**DESIGN, CONSTRUCTION AND FIT OUT OF
NATIONAL LIBRARY OF TIMOR LESTE**

DOCUMENT NO:
ANP/PROC/ADD/24/001

ADDENDUM No. 01

**Amendment of Bid Document for
Tender Document No.: ANP/PROC/ITB/24/001
In accordance with ITB 8.1, Section 1 (Instructions to Bidders) of Bidding Document**

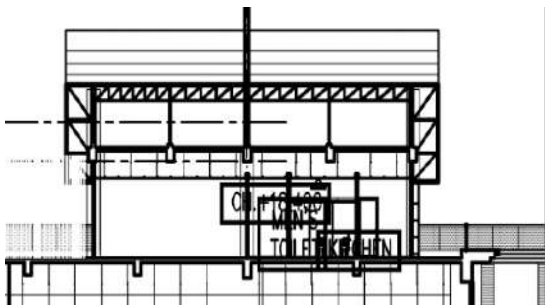
32	<p>Question: Does this project provide geotechnical, hydrogeological, or other relevant preliminary data, or will the Contractor conduct its own monitoring and then refine the design?</p>	<p>The Topography survey that required for the DED (Detailed Engineering Design) is under Contractor's Scope, for Soil Investigation Report available in previous Site Survey Report and will be provided by Employer. Additional soil investigation (SI) for</p>

NO.	QUESTION	ANSWER
		conducting DED is become contractor's consideration whether the previous SI report is enough or not Please refer response no. 10 above
33	Question: Is there a need for special design, including depth and requirements, specifically for acoustics, lighting, secondary MEP, BIM, green building, and prefabricated construction?	It is the responsibility of the DB contractor to design and construct the project to the satisfaction of the Employer including any special design. The DB Contractor shall fulfill a given design criteria. All design will be reviewed by the awarded Construction Management Consultant
34	Question: The decoration effect scheme is not shown in the conceptual scheme. Is the Contractor responsible for the scheme design and further design of this part?	Can be checked in the detail drop off drawings, the detailed design is needed to be done by successful Contractor. Refer to Section 6A- Scope of Work (page 5), this is a Design & Build Contract, so the successful Contractor will compose of a team with the relevant competencies required for a single design and construct activity for the duration of the project, providing one point of contact from contract execution through the design, build and fit-out phases.

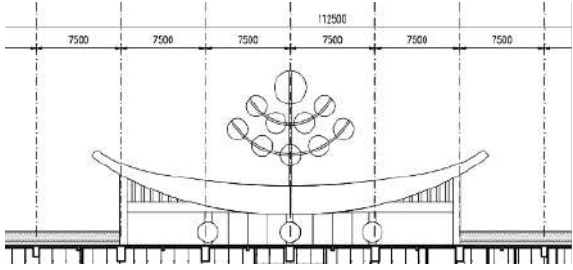
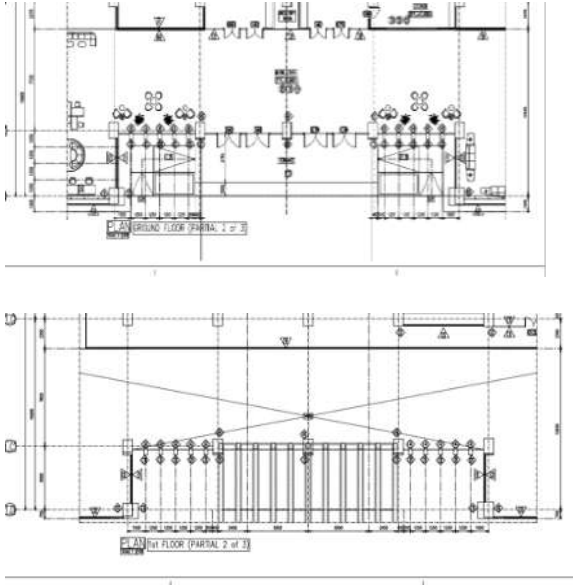
38	In Section 4 Bidding forms (Page 48), 7. The Contingency amount is fixed and the execution is subjected to the prior approval of the employer (project owner). Question: in Bill of quantities, the bidder cannot find item as Contingency.	Remove item # 7. There is no Contingency Amount is dedicated to this project.

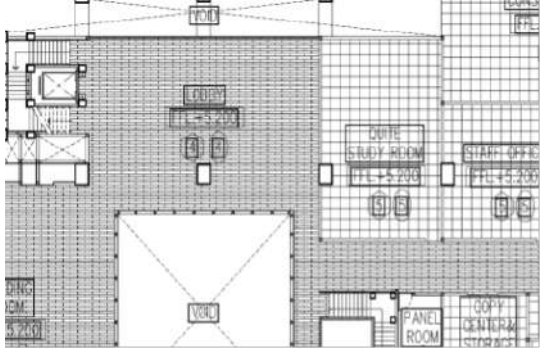
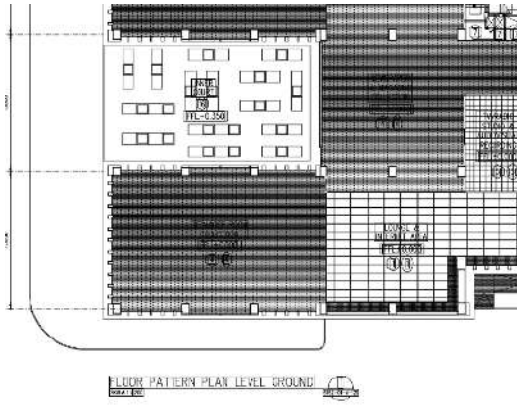
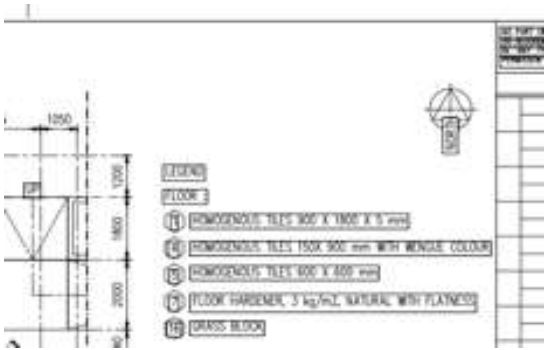
44	<p>If there is a specific amount that we should use for the bid security, could you provide us with that figure?</p>	<p>Please refer to the Special Clause of the Section 2 - BDS, for the amount to be used for the bid security. The bid security is 3 (three) percent of the Maximum Budget that is stated in the Special Clause of the Section 2 - BDS. <u>Please note that the Employer will amend the ITB 47 of the Section 2.</u></p>
45	<p>We noted there are different standards and codes shown in bidding documents, that is,</p>	<p>Please check/ refer to Scope Of Work Art. 6.4, there is a table that indicates the Code</p>

NO.	QUESTION	ANSWER
	AS standards, NZS standards, Eurocode , BS standards, AISC standards etc. So for the design of the project should meet all these standards and codes, or to use one of the above listed standards or codes for guiding our design?	& Standard for the respective item. Bidders are required to apply one of the listed standards and codes.
46	ITB 47 Bid Security Guarantee only specify that the bidder must furnish with the bid security, our question is this bid security must be issued by a bank which shall have a correspondent bank or financial institution located in the territory of Timor-Leste or not? Please to confirm it ASAP, thanks!	In case the bank issuing the Bid Security Guarantee is located outside Timor-Leste, it shall have a correspondent bank or financial institution located in the territory of Timor-Leste to make the guarantee enforceable. Please refer to response no. 18
